10.8. Draft Amendment to NSDCP 2013: 183-185 Military Rd, and 1-11 Rangers Rd & 50 Yeo St, Neutral Bay - Post Exhibition Report

The purpose of this report is to address the issues raised in the submissions to the public exhibition of the draft amendment to North Sydney Development Control Plan 2013 relating to 183-185 Military Road, 1-11 Rangers Road and 50 Yeo Street, and to finalise the draft amendment.

Figure 5:
Extract from NBVPS illustrating potential delivery of street trees to Military Road adjacent to 183-185 Military Road

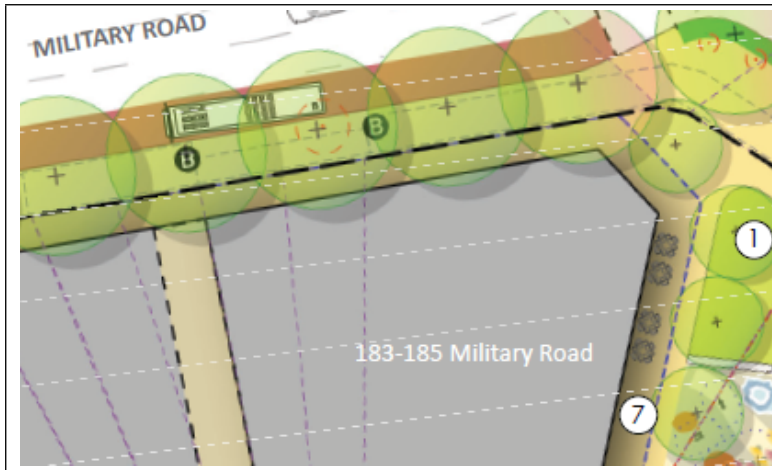
- it being impractical to have canopy trees planted within 2m of the future building façade to Military Road;
- street trees within 2m of the building façade interrupting the weather protection of a continuous awning; and
- a large amount of bus infrastructure and stops adjacent to the site.

It was stated that consideration must also be given to the anticipated horizontal spread of the tree canopy when determining how far to plant a tree from a building. It was suggested that an accepted rule of thumb was that a tree should be planted at least half the horizontal distance of the anticipated tree canopy away from a building to enable it to reach its full spread. If a canopy tree capable of growing to at least the equivalent of 4-storeys in height (i.e., 12m minimum) as per the proposed control will have a canopy width of around 10-12m as a minimum and should be planted at least 6m from any building.

Figure 5 clearly shows the base of the tree would be solely within the road reserve and away from the property boundary and that the requirement for the increased setback was more to accommodate a widened footpath and expected canopy coverage. One of the reasons for the positioning of future trees adjacent to the kerb was to assist separating pedestrians from vehicular traffic.
